Revision of Manuscript Number: IEEE-TPWRS-01391-2021, version 1 January 2, 2022
Journal: IEEE Transactions on Power Systems
Author: Abhishek Halder, Kenneth F. Caluya, Pegah Ojaghi, Xinbo Geng

Response to decision:

Response to AE:

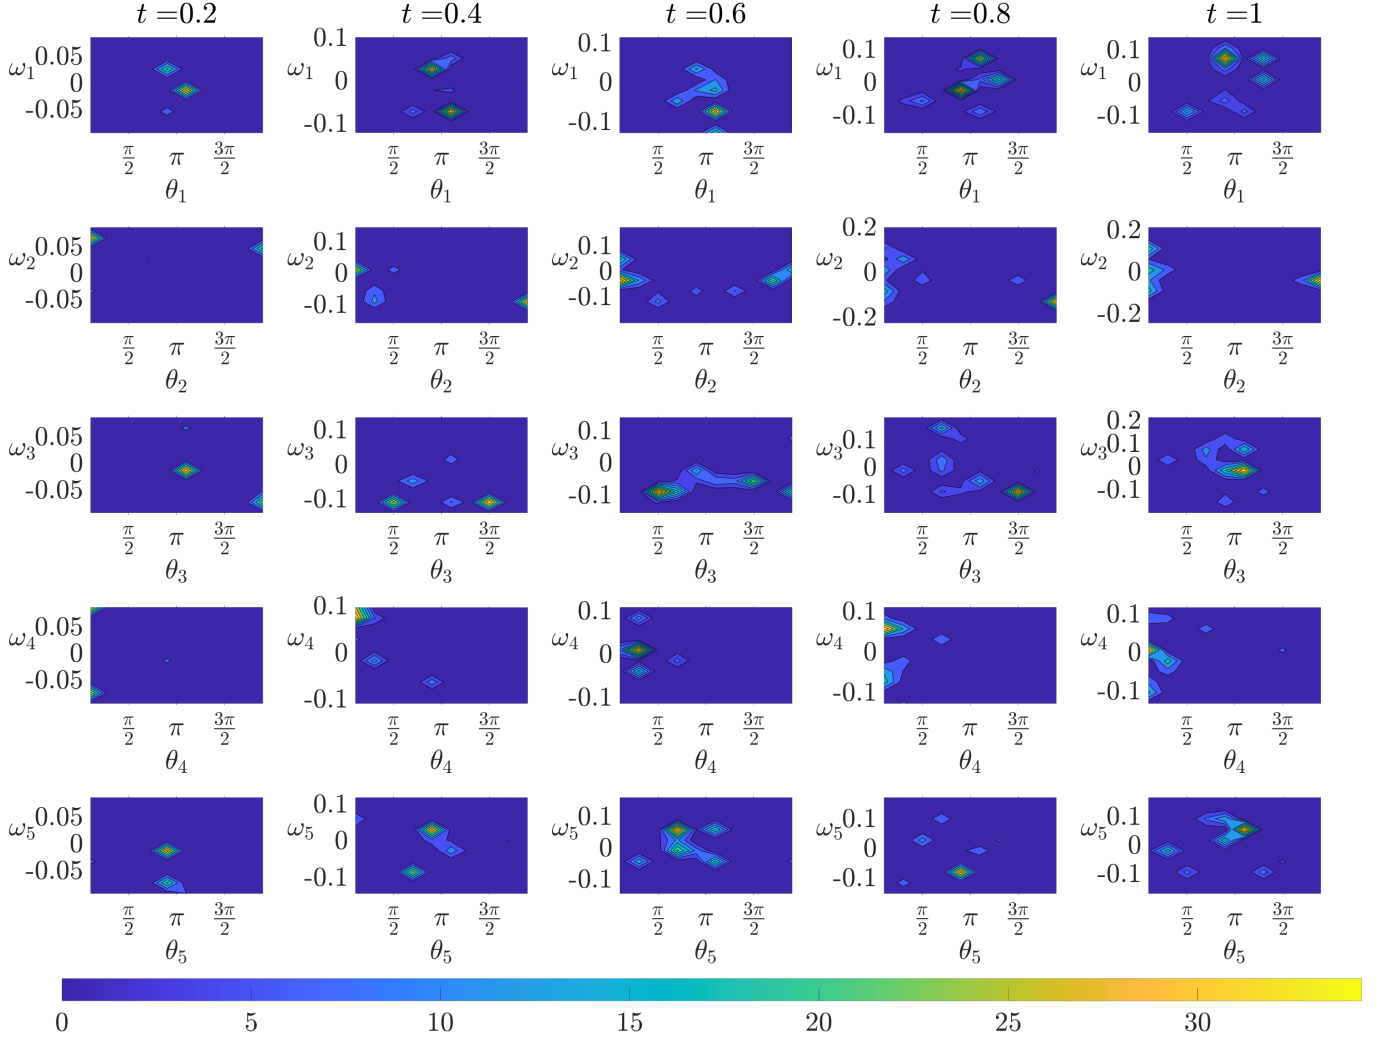
Figures 5 and 6 are unreadable.

Regarding the style of plots, we had considered plotting the bivariate marginals as planar contour plots (as in Fig. 1 in this rebuttal document) but decided against it because of the following two reasons.

First, in our opinion, this kind of plot is scientifically misleading as they hide the fact that these bivariate marginal PDFs are not really supported on the plane, or the subsets thereof, but instead have cylindrical supports. Our message that the proposed method explicitly accounts this manifold geometry in the computation, would be missed had we chosen to make the plots as per populist cognitive bias on behalf of the readers. That the planar plots evoke a sense of familiarity cannot be a scientific argument in favor of it.

Second, the planar contour marginal plots require additional mental efforts from the readers to correctly parse the statistical information conveyed. For instance, consider the fourth column, second row subplot in Fig. 1 in this rebuttal document. It is upon the reader to parse that the two high probability regions on

the left and right of that subplot are actually referring to the same angular high probability region around $\theta_2 = 0$ rad, thanks to the periodic boundary condition on the angular variable. Our philosophy of technical communication is that the onus is on the authors, not on the readers, to clarify the scientific information as correctly as possible. And yes, we are aware that many papers in the power system literature make plots in the rectangular domain ignoring the manifold nature of the support, which in our experience, continue to add pain to the graduate students and beginning researchers trying to decipher the statistical meaning conveyed in those plots. We prefer ours not be contributing to the accrual of such pain, and instead make plots that depict the variables as they are.
